Batemans Bay Bridge replacement project

Community consultation report for the Urban
Design and Landscape Plan

Transport for NSW | September 2021

Appendix A
Northern Foreshore

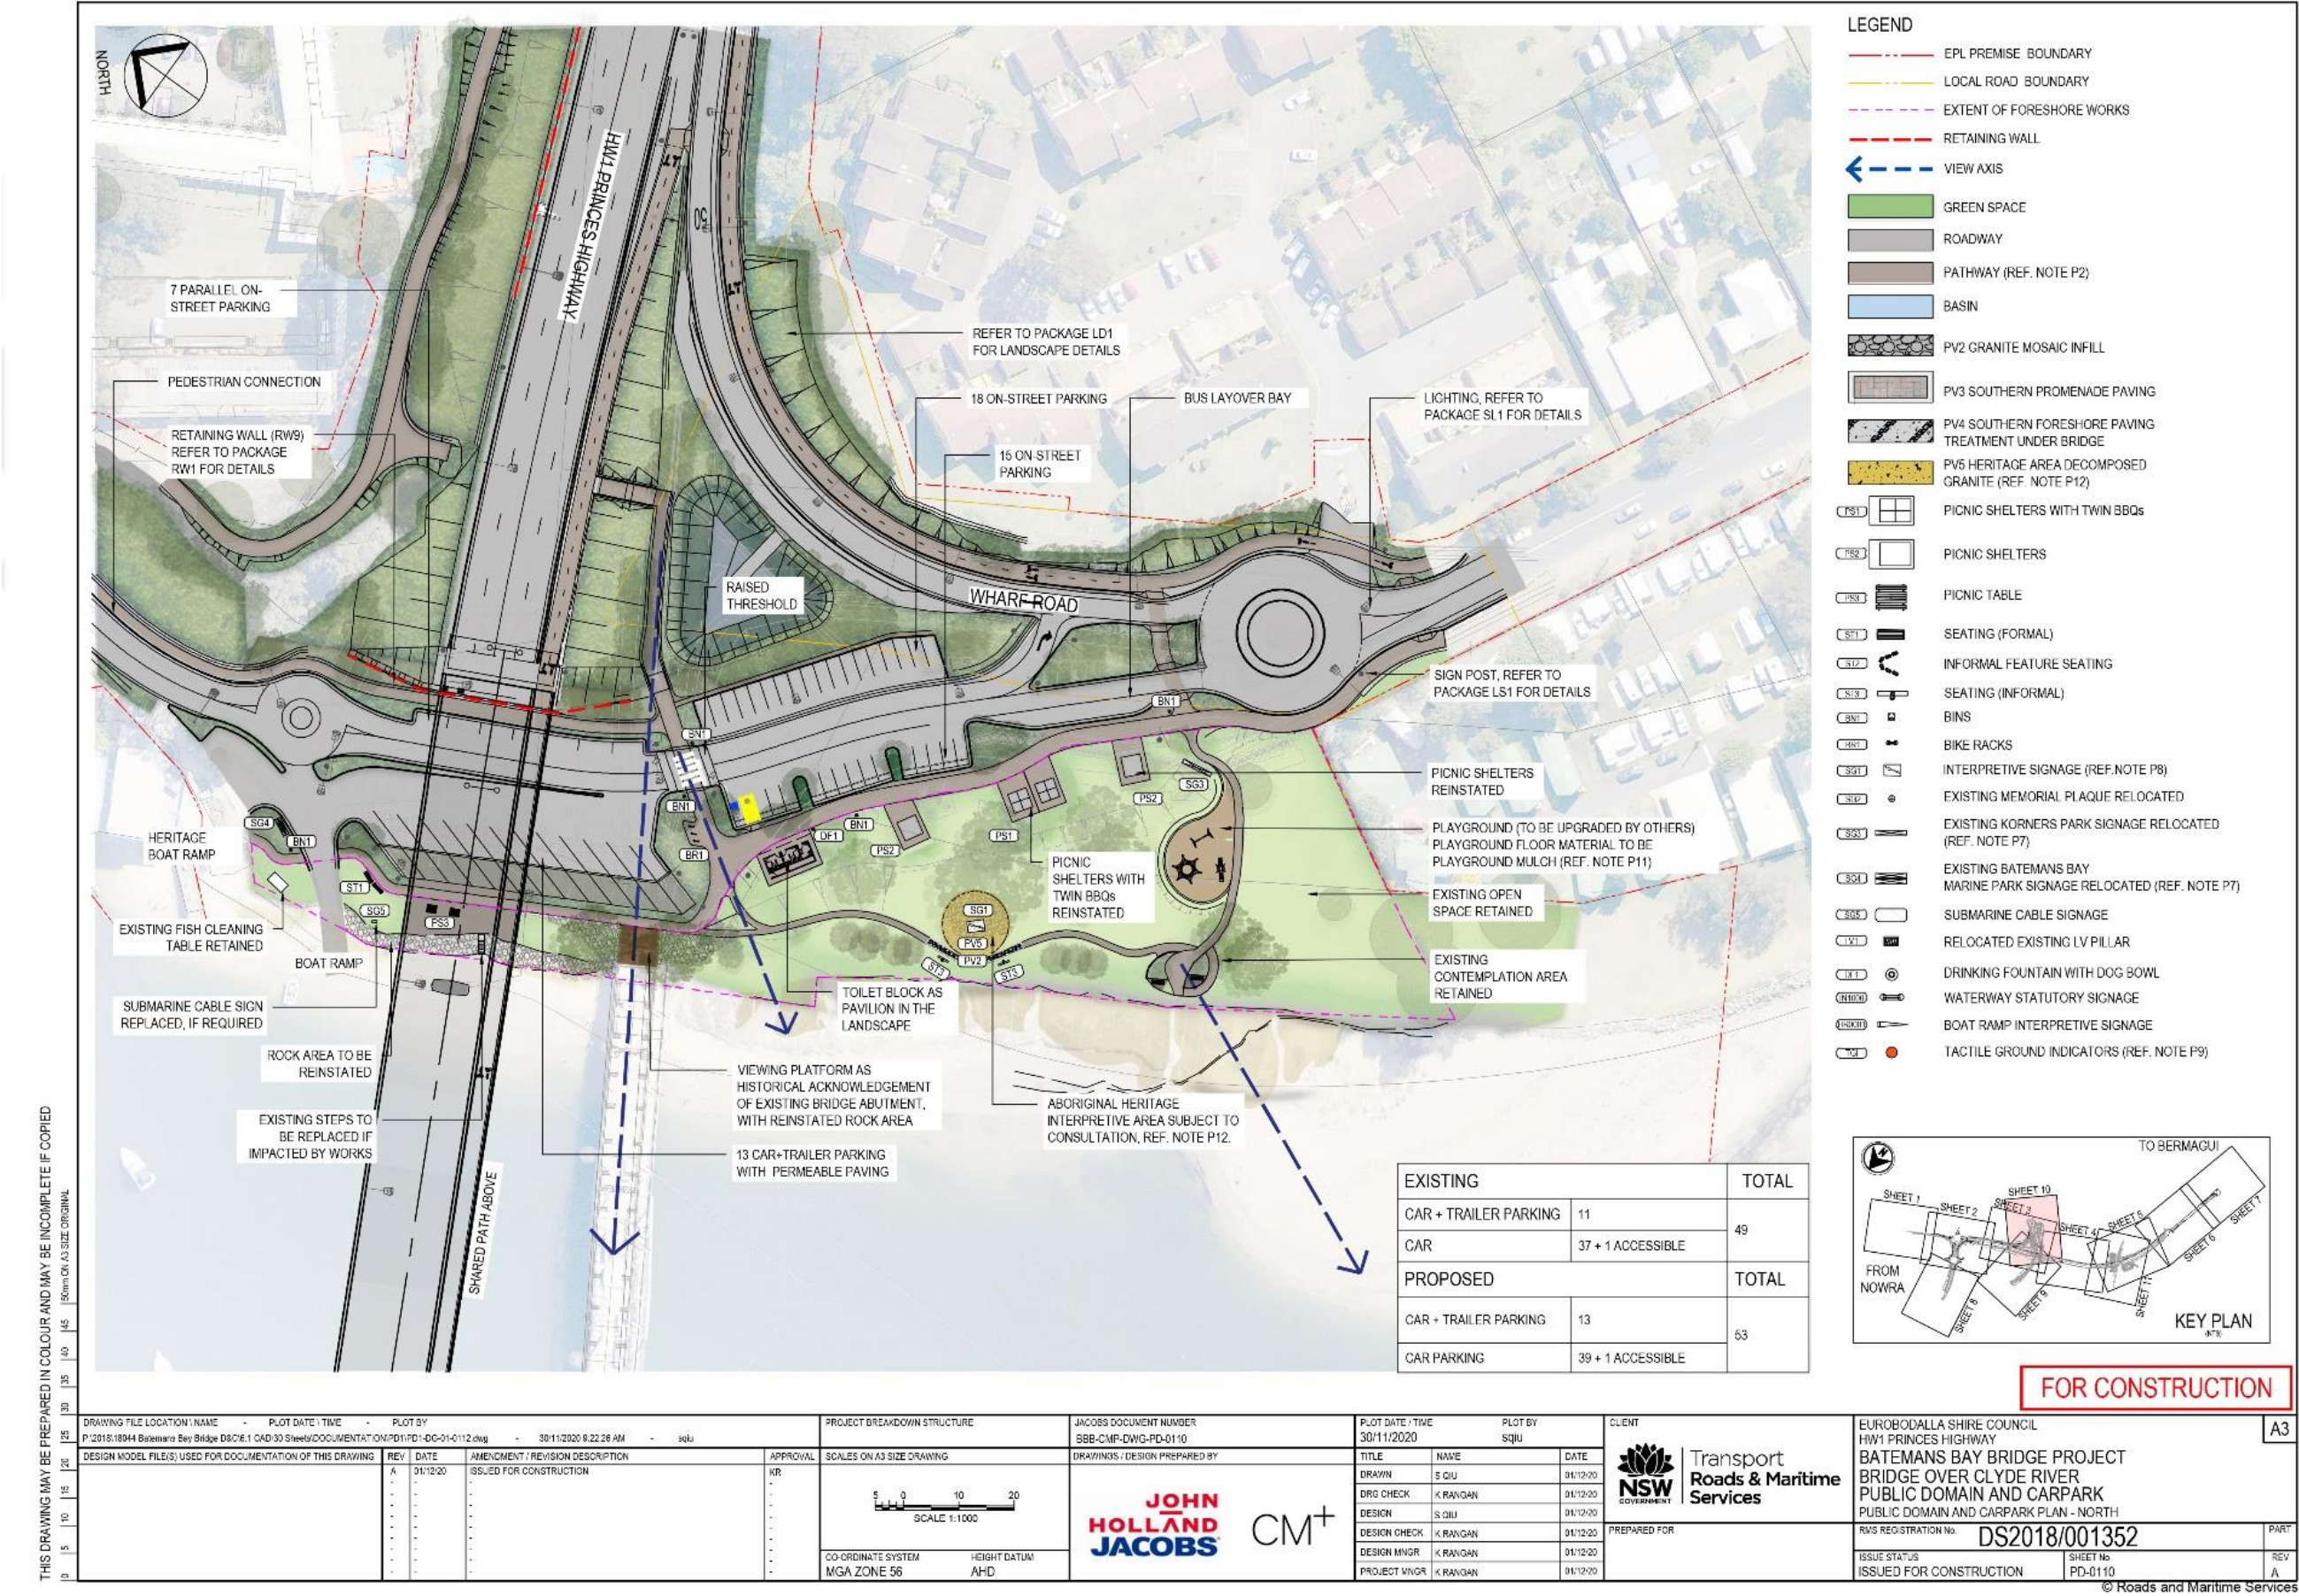
Boat ramp		
Submission reference number	Issue/s	Response
2.1.1 2.1.2 2.1.3 2.1.4 2.1.5 2.1.6 2.1.7 2.1.8 2.1.9 2.1.10 2.1.11 2.1.12 2.1.13 2.1.14 2.1.15	There were 14 requests received in relation to upgrading Old Punt Road boat ramp, including: widening the ramp to two lanes, inclusion of a boat tie-up mechanism and pontoons, increased boat trailer parking, boat trailer waiting area, wash down and fish-cleaning facilities, and lighting, permeable paving in trailer parking. Five of these suggestions included a request for silting to be addressed.	Although the Old Punt Road (northern) boat ramp will not be directly impacted by the Batemans Bay Bridge replacement and is outside the scope of the project, Transport for NSW will further investigate improvements to the design of this boat ramp and boat holding facilities. The community will be updated on the boat ramp as the investigation progresses. A boat trailer turning pathway and more boat trailer parking are part of the final design. Urban sensitive permeable paving will be incorporated in the boat trailer parking area. A fish cleaning table and lighting will be reinstated at the boat ramp.

2.2.8 4.13	Feedback was received in relation to the location of new water quality basin. Feedback included a suggestion to relocate the basin as well as concern that the basin would be dominant, with stagnate water potentially resulting in mosquito breeding and may also be unappealing and unsafe.	<p>Water quality basins have been designed to meet NSW water quality objectives for the Clyde River and provide best practice to minimise impacts to the Clyde River and surrounding wetlands listed under the <i>State Environmental Planning Policy 14</i>.</p> <p>Each basin will have an informal shape and will be graded to blend in with the surrounding landscape.</p> <p>The basins will be fenced to prevent public access. They will mostly be hidden from view using plants around the perimeter, complementing the visual amenity of the area.</p> <p>The basins are unlikely to provide a mosquito breeding environment due to design features including open water and steep banks which reduce mosquito habitat sites. The basin water levels will vary over time, in turn creating habitat for mosquito predators.</p>

Submission reference number	Issue/s	Response
2.3.1 2.3.2 4.13	Requests were received for an update to the design to reduce the walking distance to properties east of the bridge. Another submission referred to the need to ensure visibility of the Wharf Road pedestrian crossing and include traffic calming measures for pedestrian safety.	<p>In addition to a ramp along Wharf Rd to connect to the bridge shared user path, stairs are provided to allow more immediate access between the bridge and foreshore.</p> <p>The curved approach of the highway exit to Wharf Road together with the new roundabout is an effective combination for slowing traffic. The pedestrian crossings have been located based on pedestrian desire lines and to maximise sight distances.</p> <p>Pedestrian warning signs and speed restrictions are incorporated in the design to bring attention to the pedestrian crossing and highlight the local road environment.</p>

2.3.3	A comment was received regarding the location of the footpaths that could result in pedestrians taking unsafe shortcuts near the bridge embankment.	<p>A pedestrian safety fence has been included in the design between the shared user path and bridge embankment to prevent unsafe access and encourage use of the pathway.</p> <p>Direct pathways are provided to improve functionality including access to the bridge, car parking and bus parking bay. The intent of the alternative curved footpaths is to make the walk more interesting, to encourage people to meander between the various features proposed for the upgraded Korner's Park.</p>

2.4.1 4.13	A submission was received with questions about traffic flow on and near the new roundabout near the Old Punt Road boat ramp. Another submission offered an alternative configuration of Wharf and Old Punt roads for access.	<p>The northern foreshore design has been developed through consultation with the Foreshore Advisory Committee. This includes a shared pathway, additional parking, a separated one-way access for vehicle and trailer parking, access to the existing boat ramp, public facilities including toilets and shelters, and a through road connection between Wharf Road and Old Punt Road that includes a roundabout for safe access for vehicles and boat trailers.</p> <p>The roundabout allows for vehicles exiting the boat ramp and car park to turn safely onto Old Punt Road while allowing for continuous traffic flow for through traffic.</p>

2.4.2 2.4.5 4.13	Submissions were received regarding the number of proposed parking facilities. One comment proposed that the parking would not be sufficient and no bus parking was provided. Another submission offered alternative suggestions for parking configurations.	<p>The vision for the northern foreshore developed in consultation with the Foreshore Advisory Committee is for a more natural environment where a balance is found between soft landscaping finishes for recreational use such as picnic areas and hard surfaces like pavement and concrete for parking, roadways and footpaths.</p> <p>Two additional car parking and two additional boat trailer parking bays have been provided in the final design. The northern carpark was redesigned to minimise the impact on parkland while increasing the number of boat and trailer and carparks. A six-metre-high retaining wall included in the design allows for about 400 square metres of impacted parkland to be returned to the northern foreshore for use as recreational space.</p> <p>A bus layover area will be provided on the northern foreshore.</p>

2.8.1	A request was received to relocate the existing shelters further away from the viewing platform to avoid crowding, and to ensure optimum views.	The design has been improved by relocating the shelters further away from the viewing platform.
Other facilities		
Submission reference number	Issue/s	Response

Changes referred to in the table below are shown in Appendix A

Appendix B
Southern Foreshore

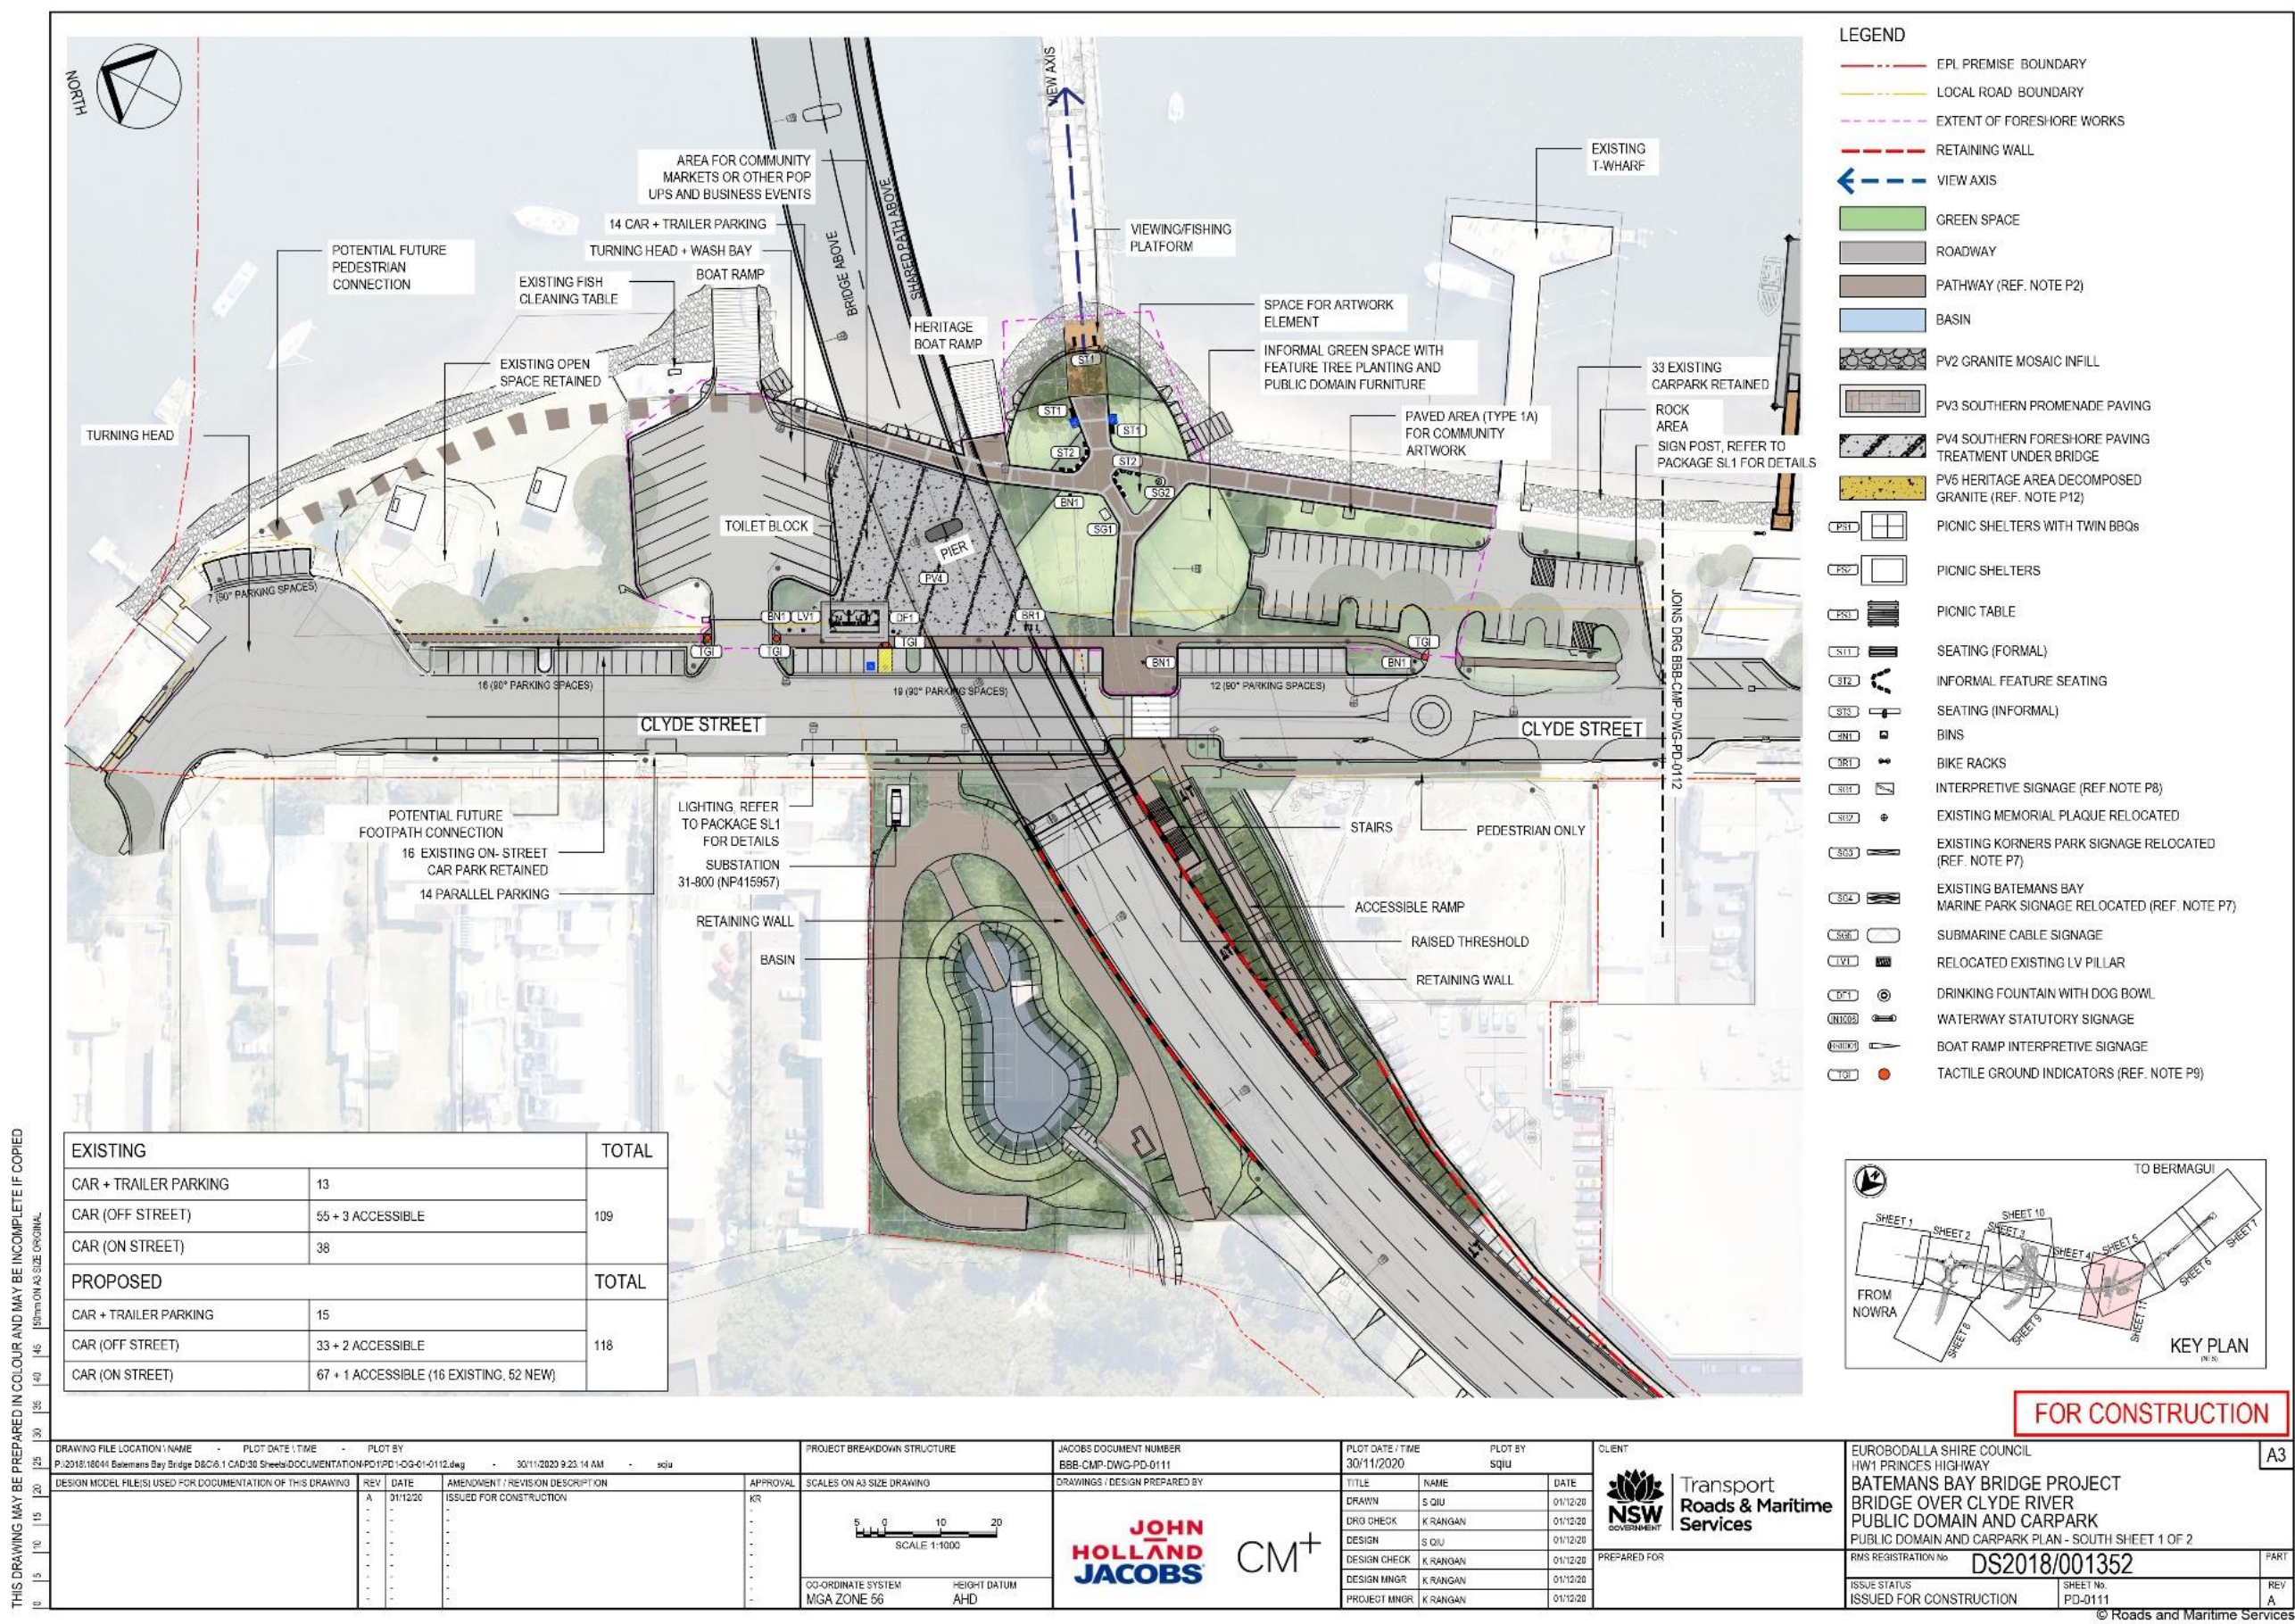
3.2.1 3.2.5 3.2.6	Three submissions were received in relation to trees on the southern foreshore. Submissions requested for more trees for natural shade and beauty, for evergreen plantings that create minimum leaf and seed/pod litter, and retaining the peppercorns where possible.	<p>The vision for the southern foreshore is for a more urban space that can be used for markets and other public events.</p> <p>There was a balance struck between soft landscaping finish and the required hard surfaces like pavement and concrete.</p> <p>Existing car parking and boat trailer parking will be maintained.</p> <p>Peppercorns and Burrawangs will be kept where possible together with additional native tree plantings.</p>

3.2.9	A submission was received about the water quality basin being inappropriately located near tourist accommodation facilities, which could result in mosquito breeding.	<p>Water quality basins have been designed to meet NSW water quality objectives for the Clyde River and provide best practice to minimise impacts to the Clyde River and surrounding wetlands listed under the <i>State Environmental Planning Policy 14</i>.</p> <p>Each basin will have an informal shape and will be graded to blend in with the surrounding landscape.</p> <p>The basins will be fenced to prevent public access. They will mostly be hidden from view using plants around the perimeter, complementing the visual amenity of the area.</p> <p>The basins are unlikely to provide a mosquito breeding environment due to design features including open water and steep banks which reduce mosquito habitat sites. The basin water levels will vary over time, in turn creating habitat for mosquito predators.</p>

Submission reference number	Issue/s	Response
3.3.1	A request was received to ensure provision of ample parking near Clyde Street boat ramp if the adjacent area is used for markets and other events.	<p>Existing car parking and boat trailer parking numbers are maintained in the foreshore design.</p> <p>Additional car parking at the western end of Clyde street west will be incorporated in the final design.</p>
3.3.2	A request was received for multiple water outlet options and additional power outlets including three-phase and standard power. This could be positioned	Power and water outlets will be provided in the services corridor at this location. The services corridor will be connected to the toilet block and access will be managed and maintained by Eurobodalla Shire Council.

3.3.5	A request was received to limit the number of trees near the event space.	The vision for the southern foreshore is for a more formal space that can be used for markets and other events. The number of trees near the event space are limited, however some tree planting is included to provide shade while maintaining views.

Changes referred to in the table below are shown in Appendices B, C and D.
